Project Title: Chick-fil-A at Gibson Building Permit #: _____ City Drainage #: _____

Re: **Chick-fil-A**
1600 Gibson Blvd. SE
Grading and Drainage Plan
Engineers Stamp Date 12/15/14 (M12-D015C)

Merrick & Company has reviewed the comments received on February 26, 2015 regarding the proposed Chick-fil-A located at 1600 Gibson Blvd. SE. The following summarizes Merrick's response to the comments provided by the City of Albuquerque.

SHEET TITLE
**DEVELOPED
DRAINAGE PLAN**

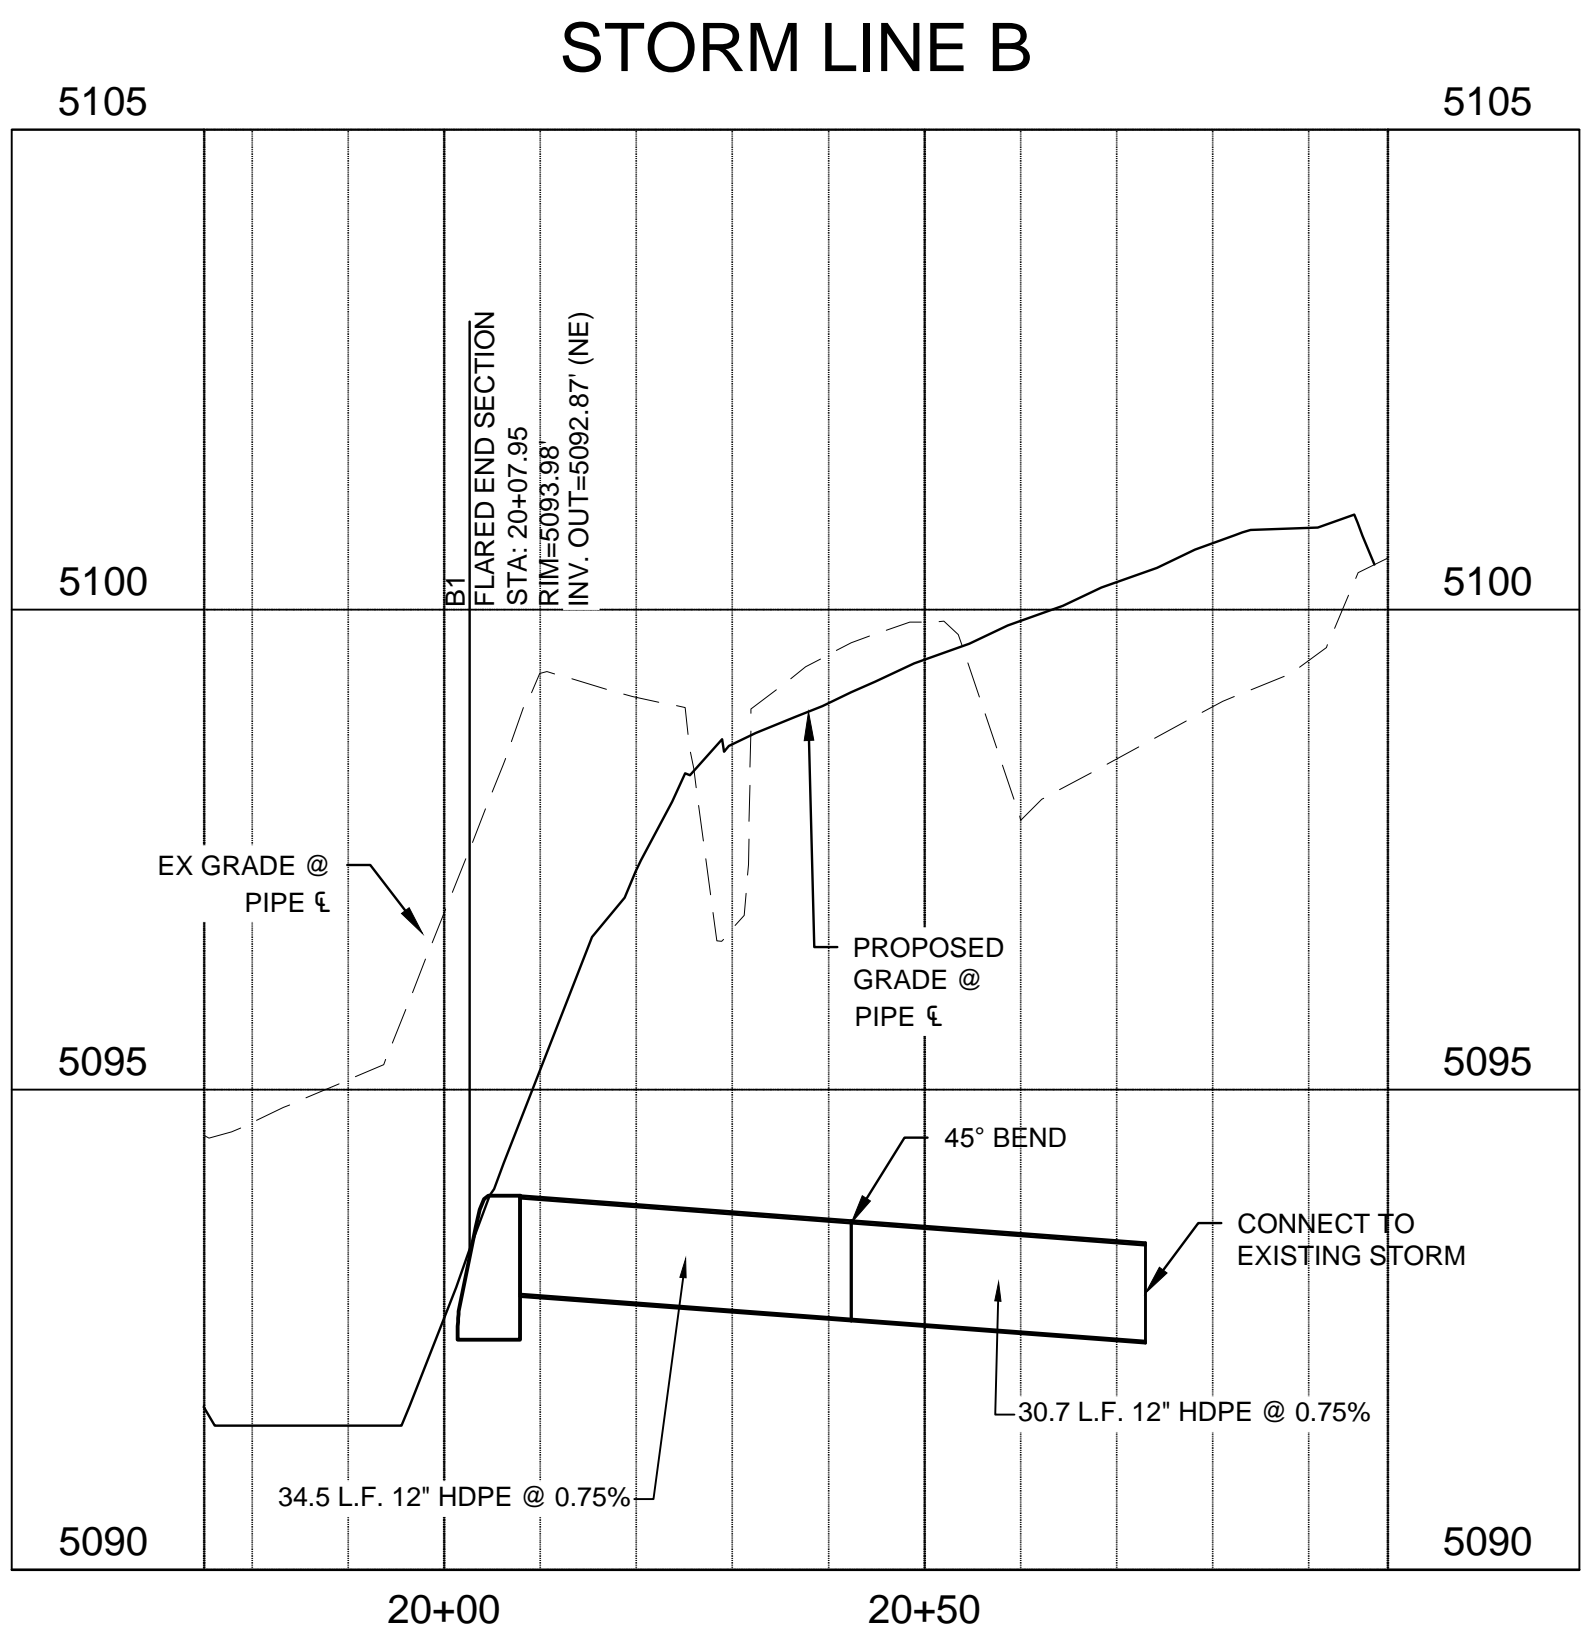
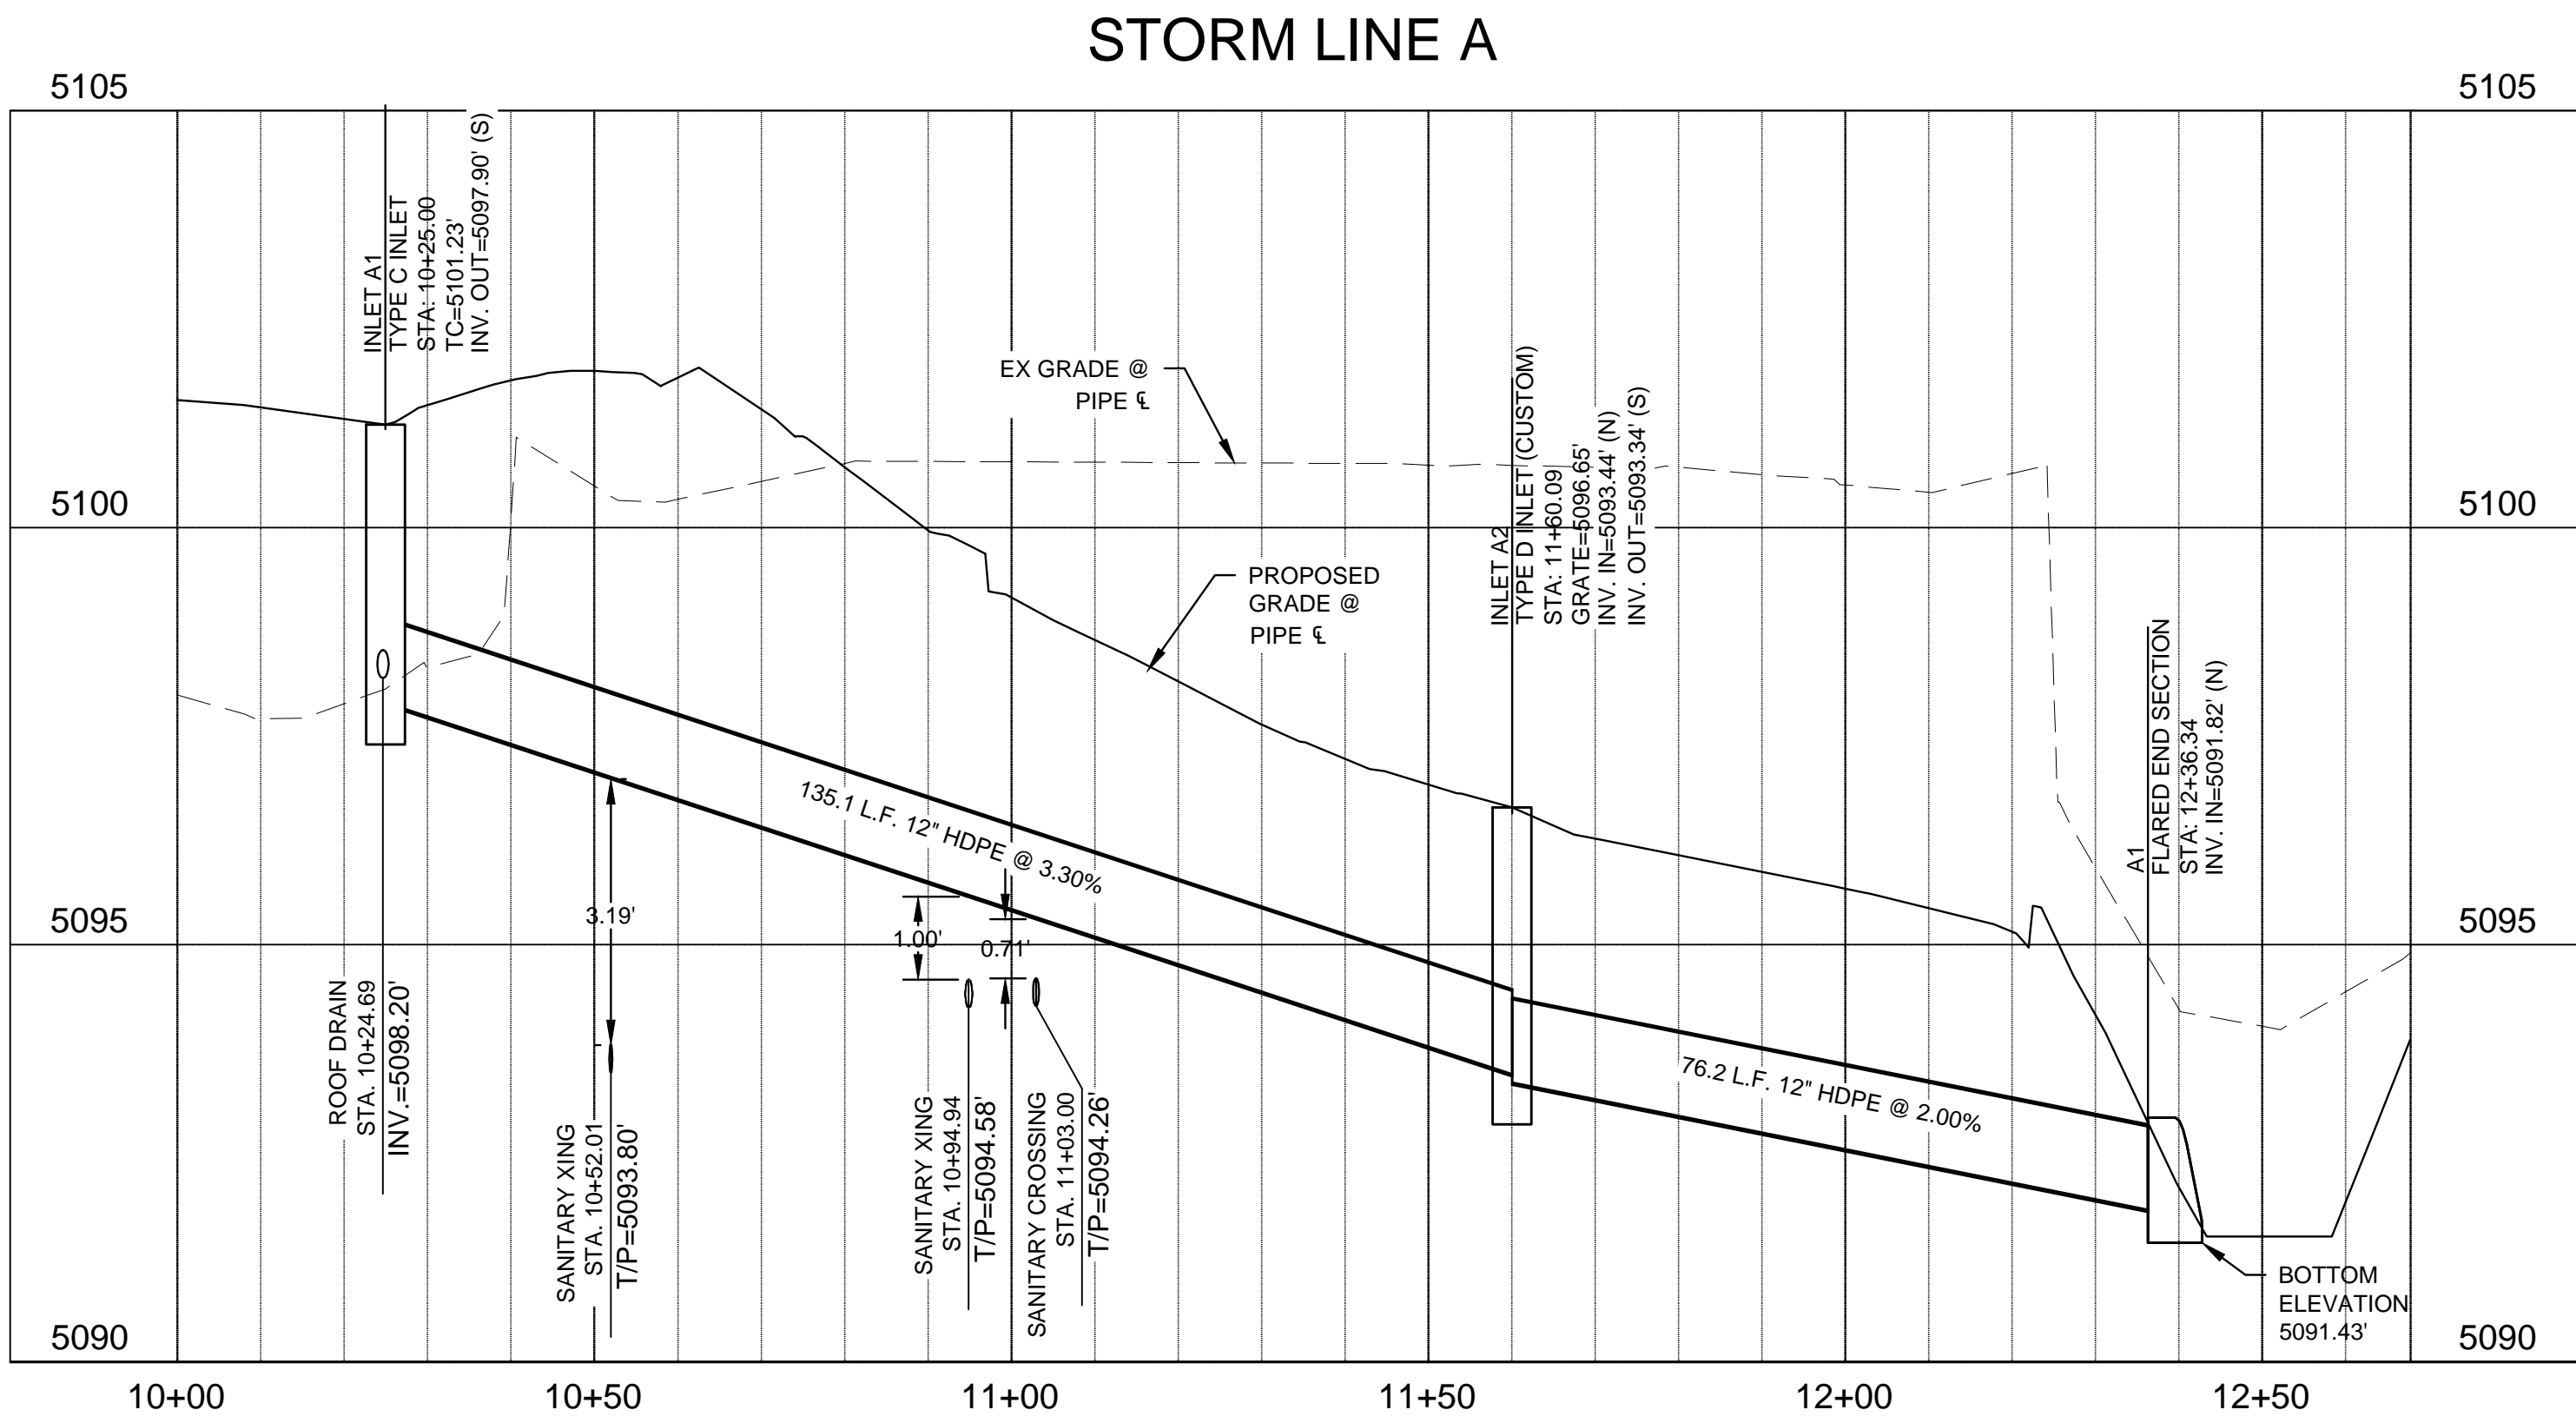
- Mention of the first flush per EPA standards is required. The amount required is .34" times the impervious area. We believe there is enough landscape area to accomplish this requirement.

- Provide the vicinity map for the area. Also provide the FIRMette or mention the flood zone and map page.

- Show the roof flows.

- Basin B-1 needs to flow through a first flush retention pond before leaving the site.

Response: The first flush has been mentioned in the drainage statement located on sheet C-3.2.

Response: Vicinity map and FIRMette have been added to the drainage pages.

Response: Roof flows have been added to the drainage map.

Response: A retention pond has been added to retain the first flush from basin B-1
